CITY OF ROCKWALL CITY COUNCIL MEMO

AGENDA ITEM: **SP2016-008**; Carmel Car Wash

City of Rockwall Project Plan Review History

1 SITE PLAN 1" = 20'

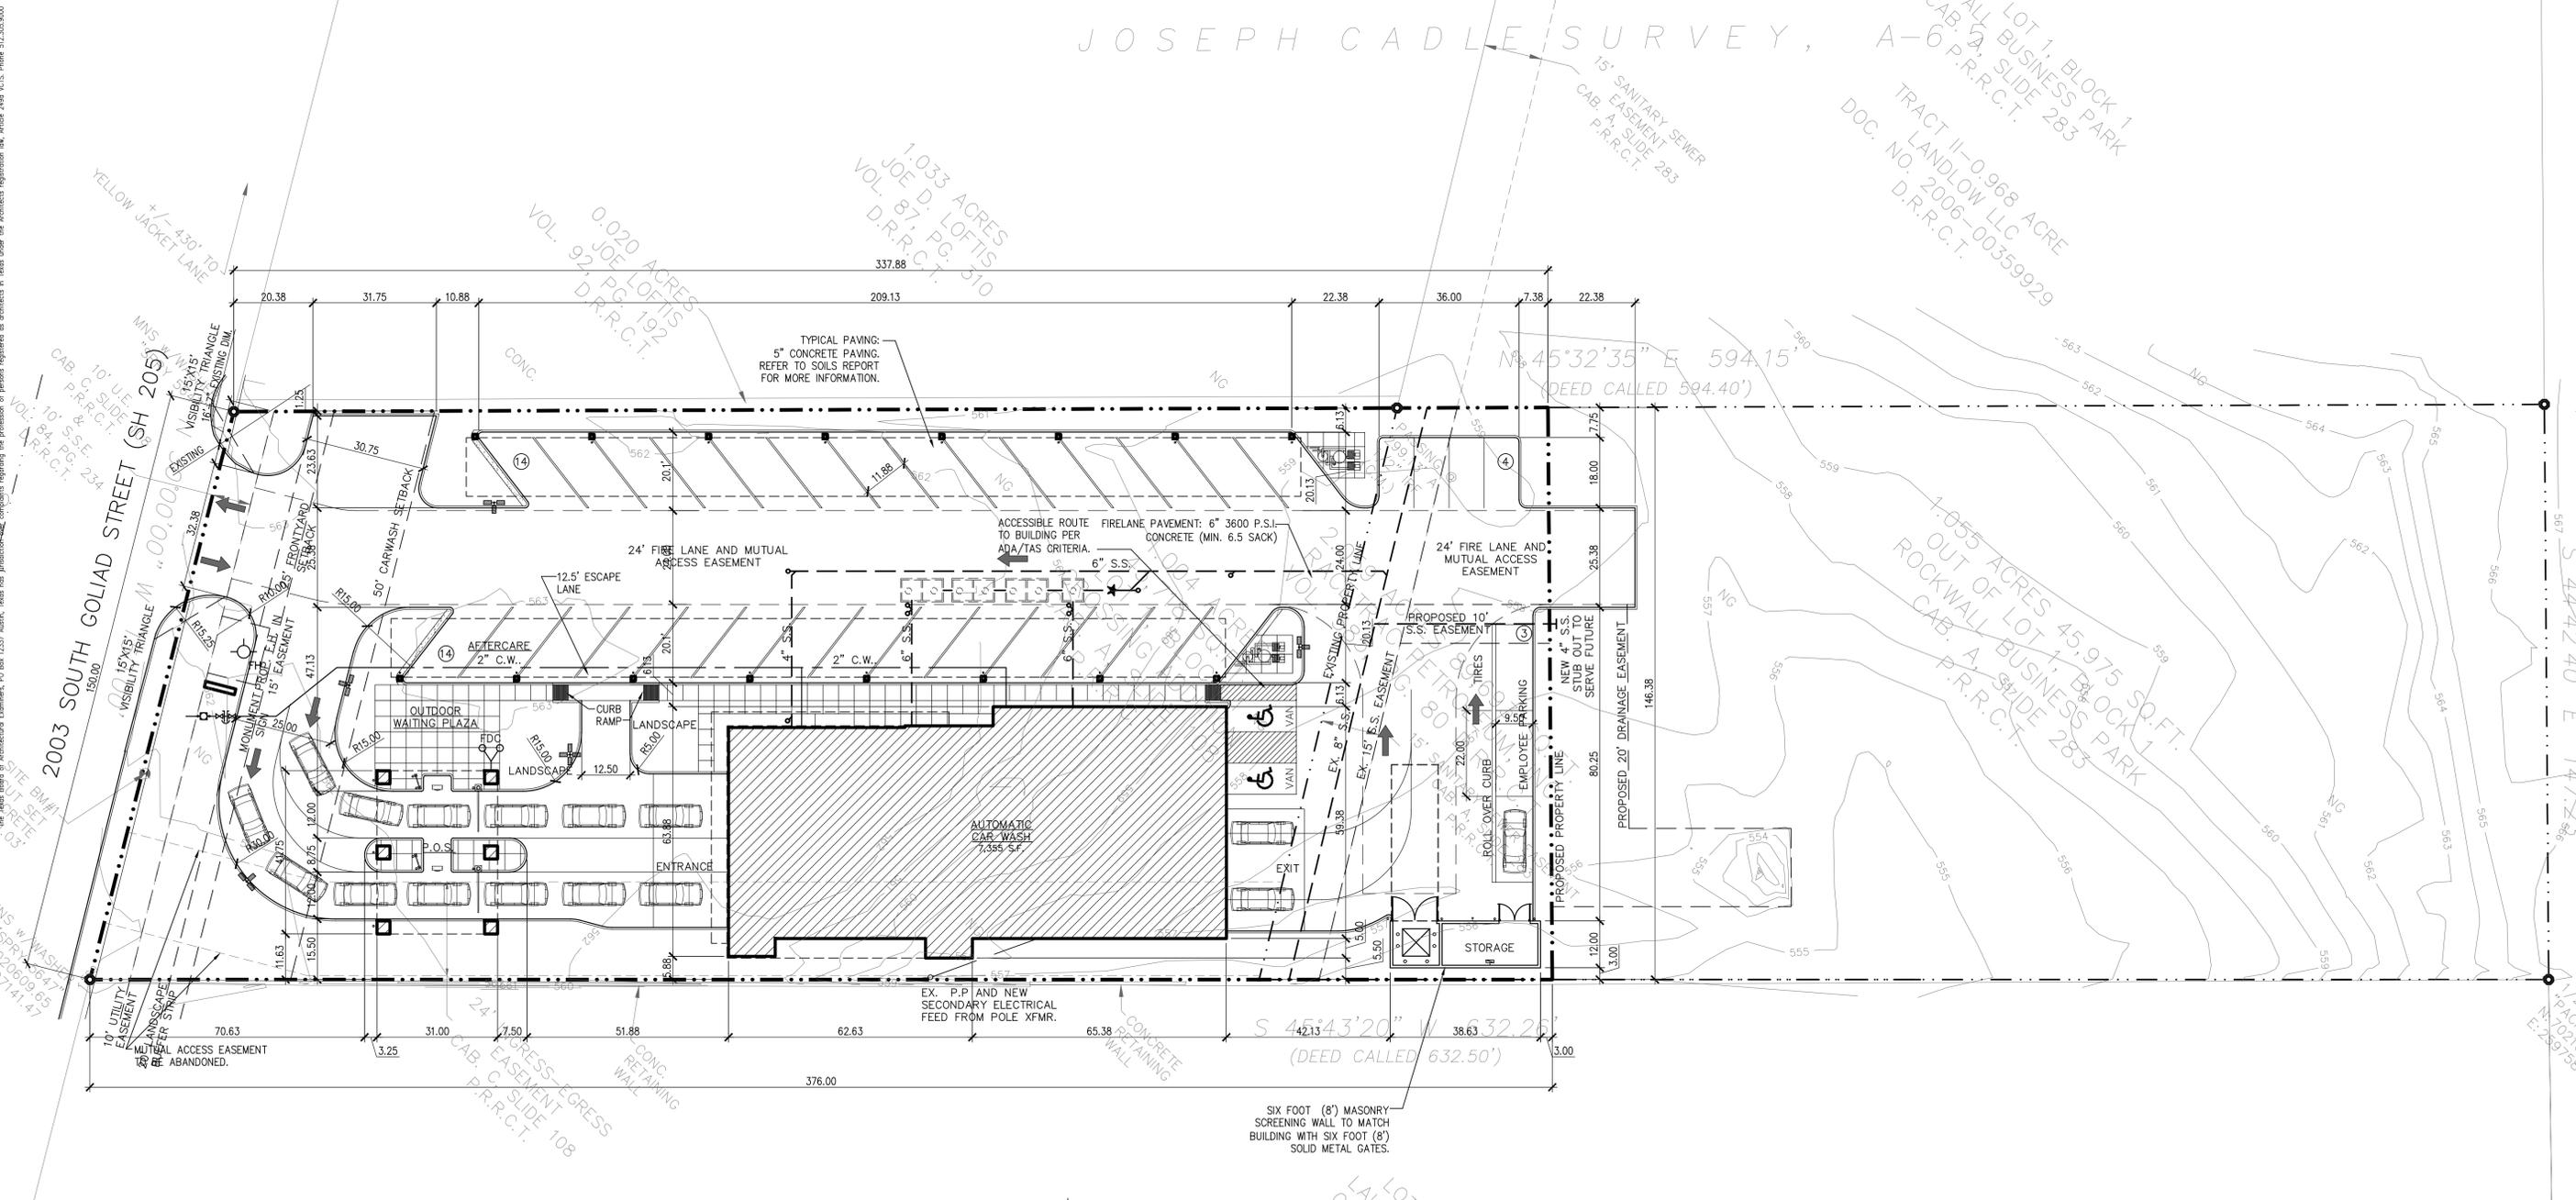
Type of Review / Notes	Contact	Sent	Due	Received	Elapsed	Status	Remarks
BUILDING	John Shannon	4/15/2016	4/22/2016	4/22/2016	7	APPROVED	
ENGINEERING (4/19/2016 12:19 PM AW) Parking needs to be 90 degrees along the 2 way fire lane and access easement Fire hydrant to be in a 15' wide easement Verify that the signage isn't in an easement Fire lane to be a minimum of 6" 3,600 psi concrete (min 6.5 sack) Parallel parking is a minimum of 22'x9' Need more dimensions (see markup) Need off-site easements for drainage and fire lane/access Entire lot must drain to the east to existing drop inlet. No structures in easements...including dumpsters. Move dumpster Stub sanitary sewer out to the property to the east in a 15' easement.	Amy Williams	4/15/2016	4/22/2016	4/19/2016	4	COMMENTS	See Comments
ENGINEERING (5/3/2016 3:17 PM AW) Sewer easement for the stubout is a minimum of 15' wide and it is required to be a minimum of an 8" pipe connected to the existing sewer with a manhole. Need to extend an 8" water to the rear lot from SH 205 Need to label the handicap parking to be 20'x9' See attached markups	Amy Williams	5/3/2016	5/10/2016	5/3/2016		COMMENTS	See Comments

1 WEST (FRONT) ELEVATION 1/8" = 1'-0"

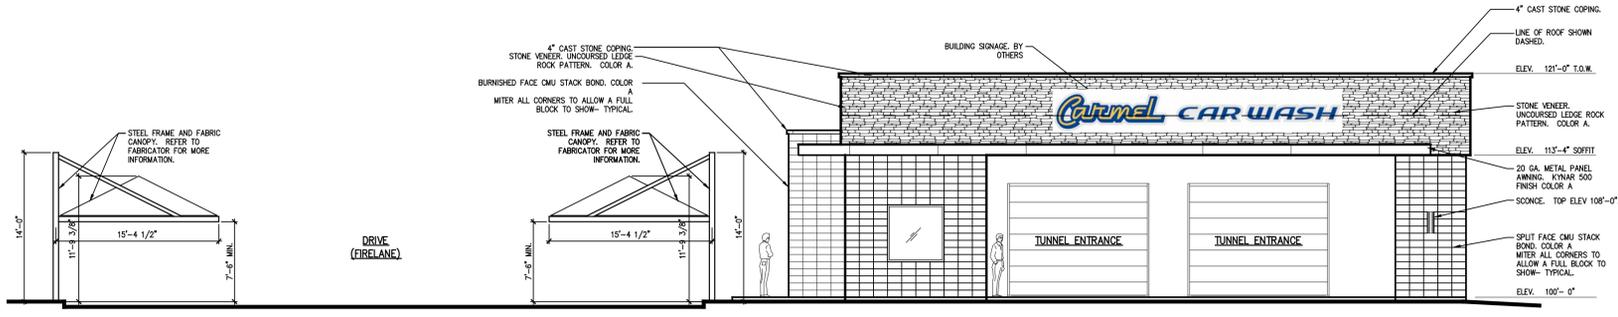
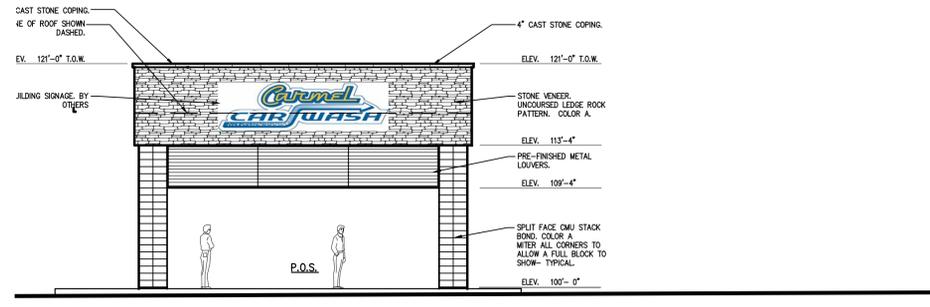
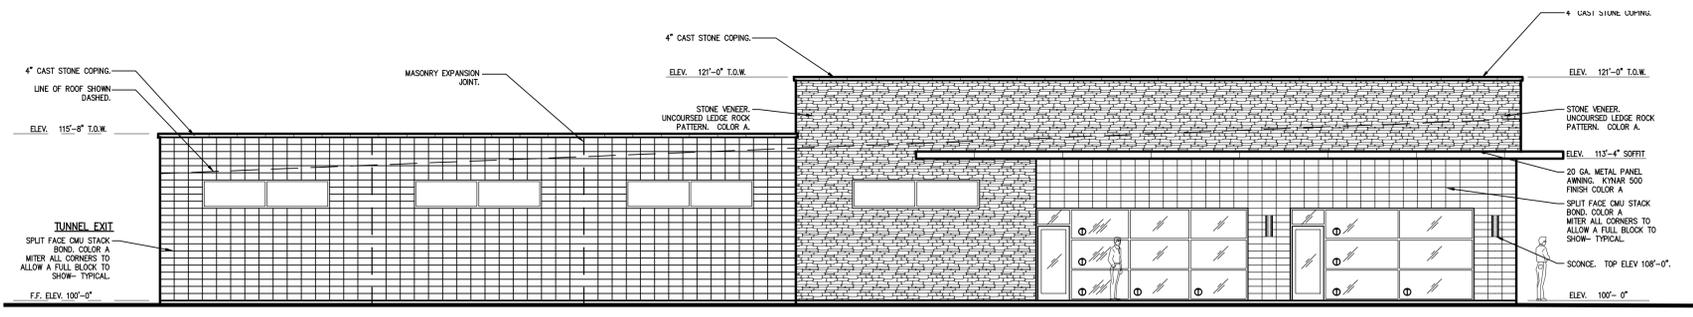
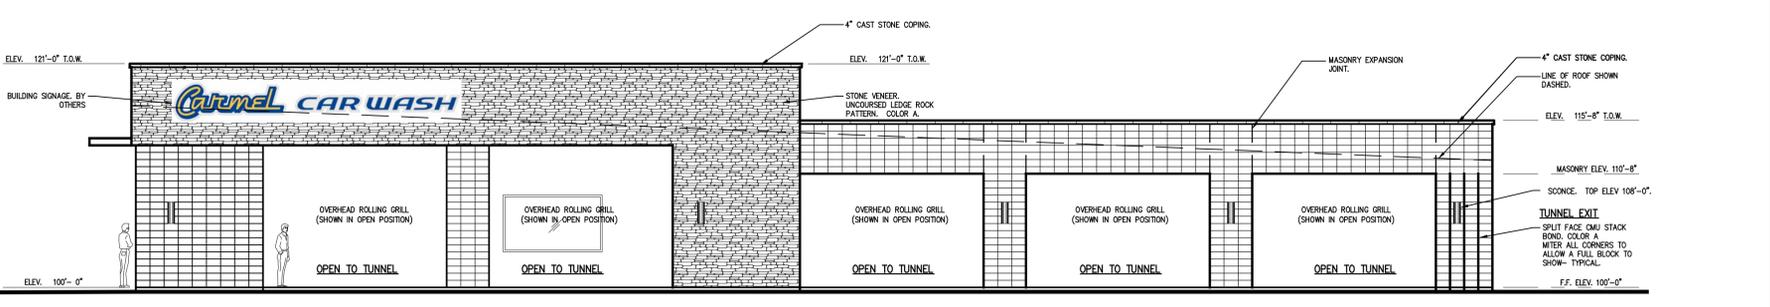
M.31	Building Elevations.	Please provide a spec on stone used in elevation. Also, please note that Custom concrete masonry units (normal or heavy weight blocks with an integral color that is sandblasted, burnished or has a split face) are allowed.				
M.32	Building Elevations.	Please provide a spec of the storage building located on the site.				
M.33	Building Elevations.	Each exterior wall shall consist of 90 percent masonry material including a minimum of 20 percent natural or quarried stone. Please ensure that the East Elevation includes 90% masonry, including 20% natural or quarried stone, or please apply for a variance from City Council.				
M.34	Building Elevations.	Please indicate the parapet wall by dashing in the top of roof deck.				
M.35	Building Elevations.	Please indicate any additional design elements for the base, wall, or parapets. Be sure to include the location, size, color, and material of any proposed structure.

M.36	Building Elevations.	Any carwash with entrances and exits to a carwash that directly face any public street shall require a variance.				
M.37	Building Elevations.	The wall on the south side of the building as well as the canopies will need to be 1-hour fire rating or they will need to be setback 10'.				
I.37	The Architectural Review Board (ARB)	meeting for this case will be held on April 26, 2016.				
I.38	Staff has identified the aforementioned items necessary to continue the submittal process. Please make these revisions and corrections, and provide any additional information that is requested. Revisions for this case will be due on May 3, 2016; however, it is encouraged for applicants to submit revisions as soon as possible to give staff ample time to review the case prior to the May 10, 2016 Planning & Zoning Meeting. The Planning & Zoning Work Session meeting will be held on April 26, 2016.

1 SITE PLAN - PHOTOMETRIC
 1"=20'-0"

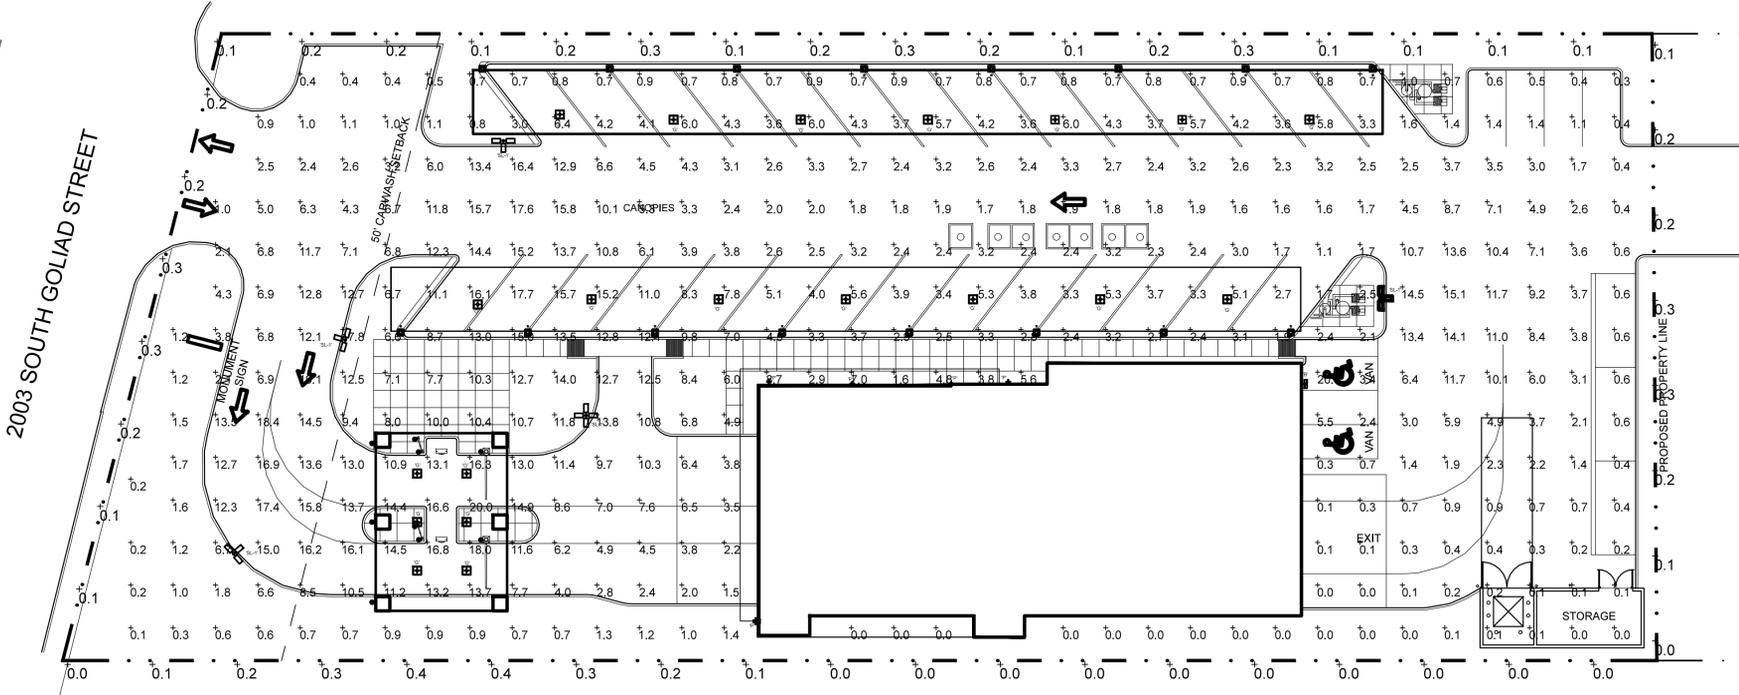
Type of Review / Notes	Contact	Sent	Due	Received	Elapsed Status	Remarks
M.26	Photometric.	No lighting facilities shall distribute more than 20 of one footcandle of light on the remainder of the property. Please look at the lighting at the entrance of the property and try to get it as close as possible to 20 FC.				
M.27	Photometric.	Parking areas are not the exceed a maintained average of 1.5 foot candles at the ground level and shall not distribute more than 0.2 of one foot candle of light upon any adjacent property. Please look at the lighting for the employee parking to get this as close as possible to the requirements.				
M.28	Photometric.	Please try and make the lighting symbols clearer so that it is easier to distinguish each symbol.				
M.29	Photometric.	Please provide cut-sheets for all exterior lighting (e.g. wall packs, canister lighting, etc.).				
M.30	Building Elevations.	Please label all roof mounted mechanical equipment and how these will be screened from view.
